SHAWNEE CITY LAKE NO. 1 DAM PRELIMINARY ENGINEERING REPORT

City of Shawnee

January 2025

FREESE AND NICHOLS, INC.
5100 E. Skelly Dr., Suite 602
Tulsa, Oklahoma 74135
(539) 444-8677

Figure 9. Historical Pavement Repairs (Geocon, 1978)

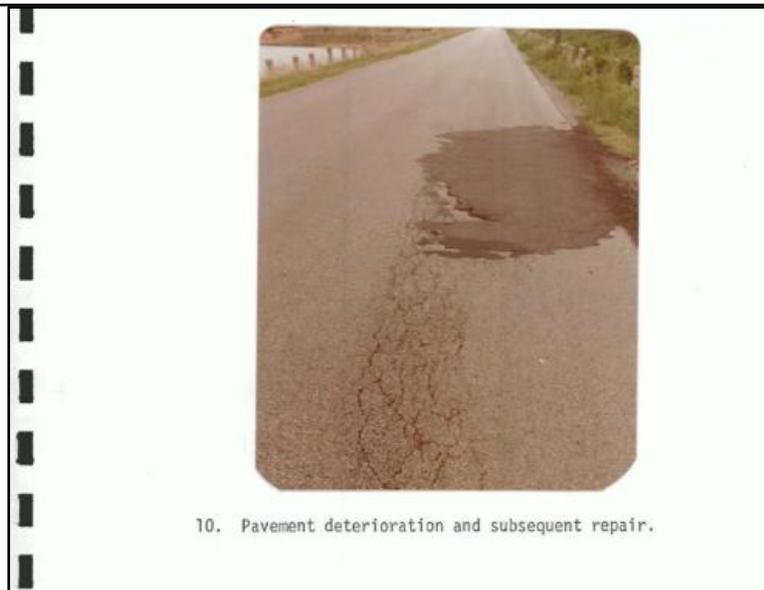
During visual observations of the dam, FNI observed leaning power poles and misaligned guard rail but did not observe tension cracks on the slope or evidence of a scarp indicating slope instability. Movement of the guard rail and depressions in the wheel path of the crest roadway pavement were observed on the west end of the dam in the reach identified as unstable by the Terracon report. Historic photos from the 1978 Phase 1 Report identified similar pavement distress (rutting and alligator cracking), which suggest the depressions in the roadway are likely from pavement subgrade failures caused by traffic loading (Geocon, 1978). See Figure 9.

The crest of the dam indicates some pavement distress due to heavy vehicle traffic. Several areas of previous road maintenance were evident. Road construction and maintenance have altered the crest profile to preclude detailed informed comments regarding embankment settlement. Visual observations of the crest, and upstream slope did not reveal any cracks, slumps, or depressions indicative of embankment instability.
